COMMENTS	RESPONSES
<p style="text-align: right;">Comment Letter I39a</p> <p>June 20, 2017 Michelle Irace Planning & Development Services County of San Diego 5510 Overland Avenue, Suite 310 San Diego, CA. 92123 Re: Harmony Grove Village South (HGVs) Draft Environmental Impact Report PDS2015-GPA-15-002, PDS2015-SP-15-002, PDS2015-REZ-15-003, PDS2015-TM-5600, PDS2015-MUP-15-008, PDS2015-ER-15-08-006 Dear County of San Diego,</p> <p><u>Background:</u> The following is the general description of the project from chapter 1.0:</p> <p>1.1 Project Objectives The purpose of the Harmony Grove Village South Project (hereafter referred to as "Proposed Project," "Project," or "HGV South") is to expand the contiguous Harmony Grove Village (HGV) to include a residential component that provides a mix of residential opportunities, and community center/limited commercial opportunities that complement existing elements of HGV and contribute to the overall functioning of the village as a whole. Integral considerations are to provide a pedestrian-oriented sustainable community that complements the natural environment, protects the community character, and integrates the residential, recreational, and pu

Figure 4

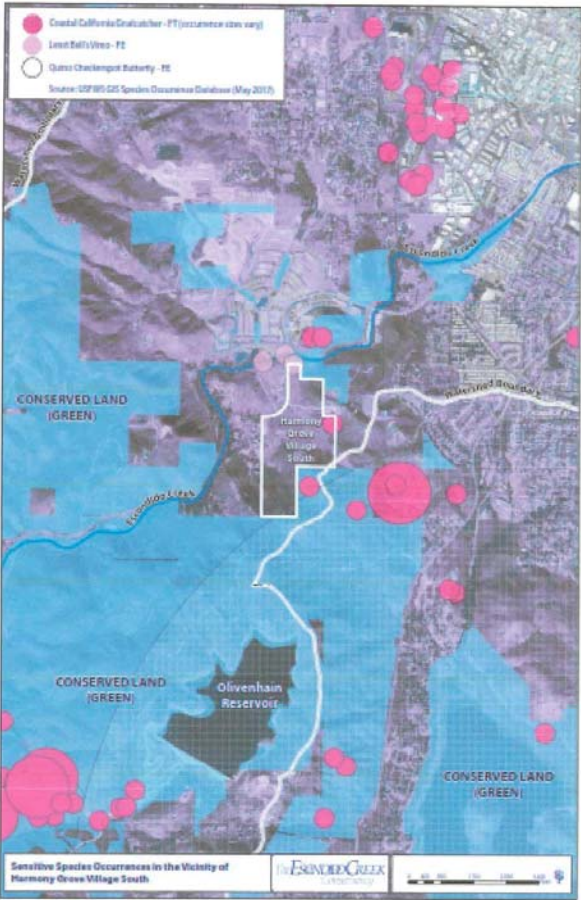
I39a-3

Figure 8 (Snapshot of Figure 3.1.2-1)

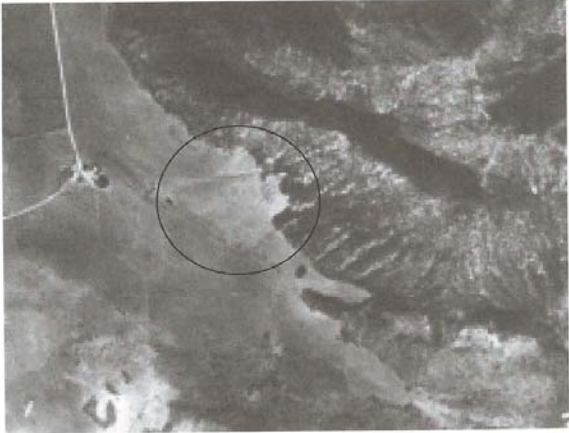
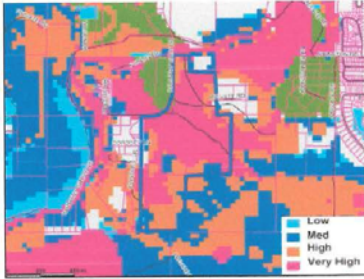
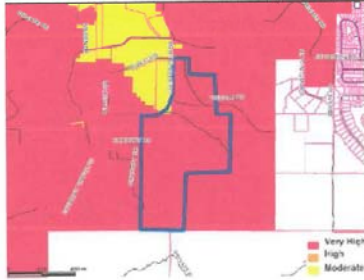
I39a-7

COMMENTS	RESPONSES
<p data-bbox="753 233 940 253">Comment Letter I39a</p>  <p data-bbox="218 751 917 797">Figure 9-note the area above the circled colluvium deposit is shows a notched out area of the hillside above which seems to indicate loss of material from that hillside.</p> <p data-bbox="218 846 669 865">Below are two photos of the same area taken from ground level:</p>  <div data-bbox="543 976 829 1065"> <p>Colluvium deposit several feet thick east/central portion of the project site.</p> </div> <p data-bbox="953 740 1010 760">I39a-7</p> <p data-bbox="575 1317 596 1336">14</p>

COMMENTS	RESPONSES
<p data-bbox="753 233 940 256">Comment Letter I39a</p>  <div data-bbox="535 371 823 466"> <p>Colluvium deposit several feet thick east/central portion of the project site.</p> </div> <p data-bbox="949 514 1008 537">I39a-7</p> <p data-bbox="218 701 905 768">Has the stability of this site been properly evaluated? What would the impact to the proposed residences if material further south on this hillside suddenly slid onto the site as the material to the north appears to have done?</p> <p data-bbox="571 1320 592 1336">15</p>
